SS 1033833 Cascadia Parksmart 100 amp Durakool relay upgrade

Cascadia and New Cascadia built prior to 1/15/18.

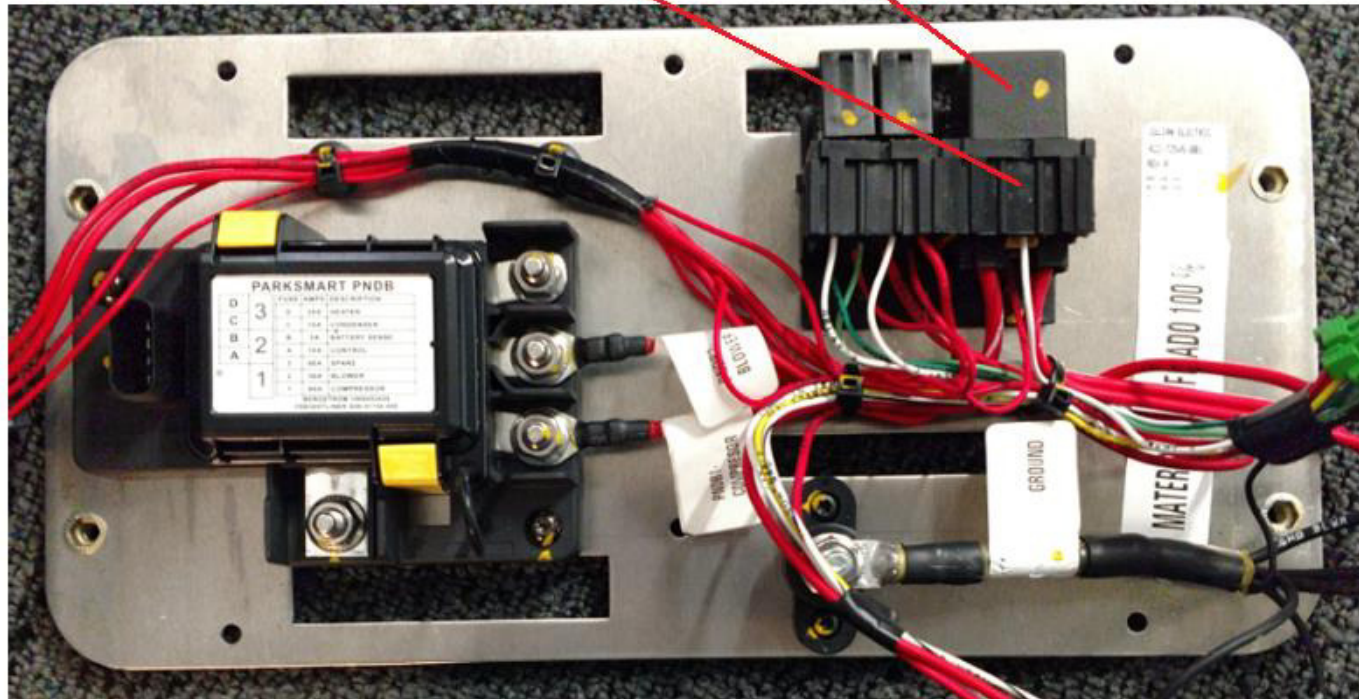
Parksmart compressor fails to operate due to distortion of the Dilblock for the LS1 100 amp Durakool relay.

Remove the Dilblock and 100 amp Durakool relay and replace with a 150 amp HD relay. See attached.

150 Amp HD Relay Retrofit

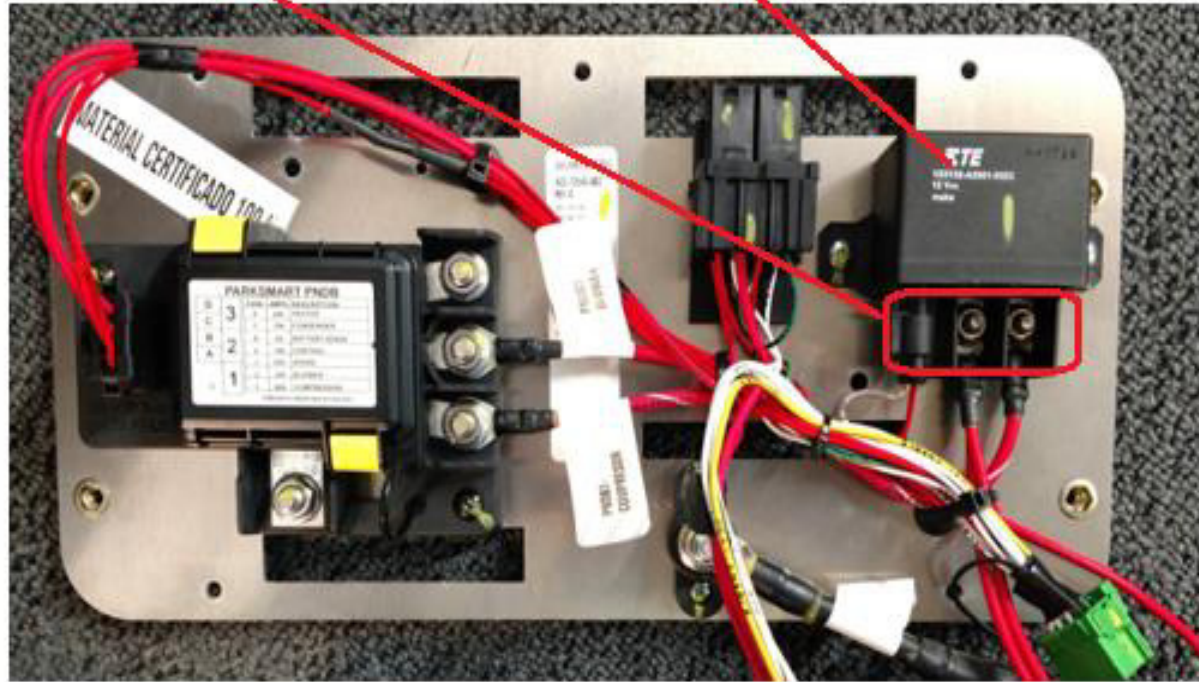
-003 version. Note 150 amp high current relay and lack of dilblock assembly

150 Amp HD Relay Retrofit

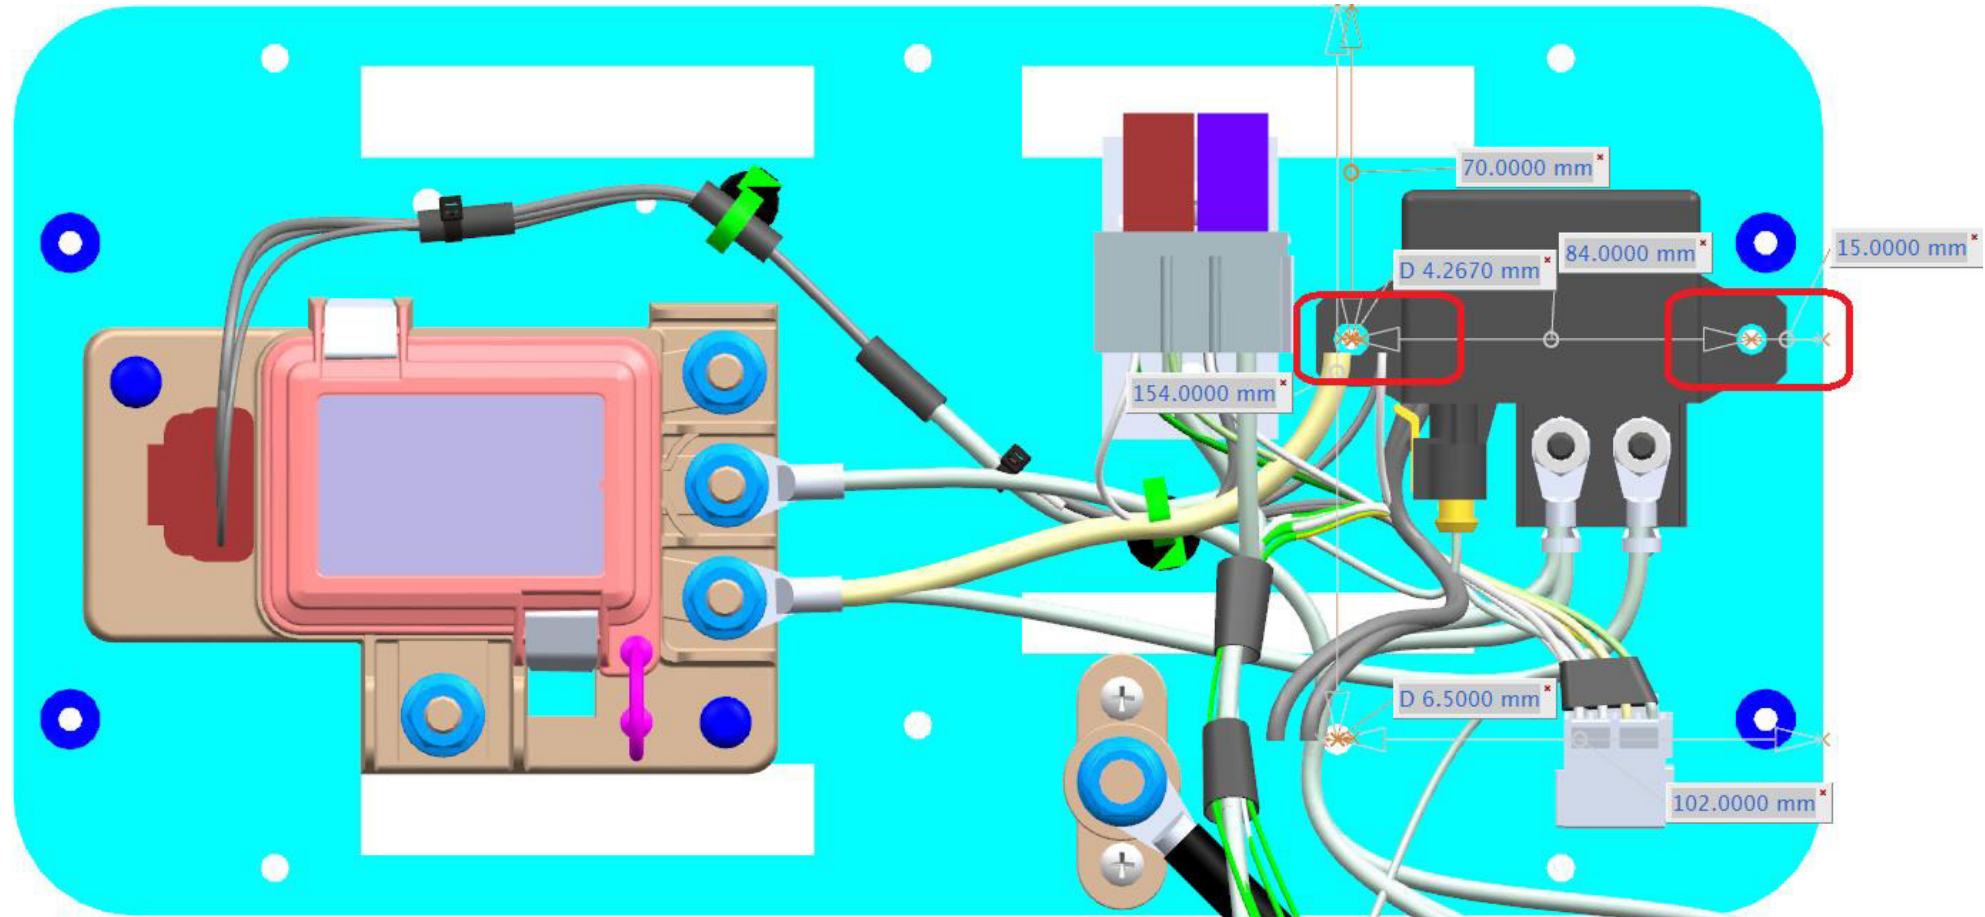
See the following template for the (2) 4.2 mm holes that will need to be drilled via a #19 drill bit for a #10 self drilling screw.

Exercise caution to prevent the power studs on the new relay from contacting the mounting plate.

Verify that no drilling residue remains in contact between the relay studs and the mounting plate.
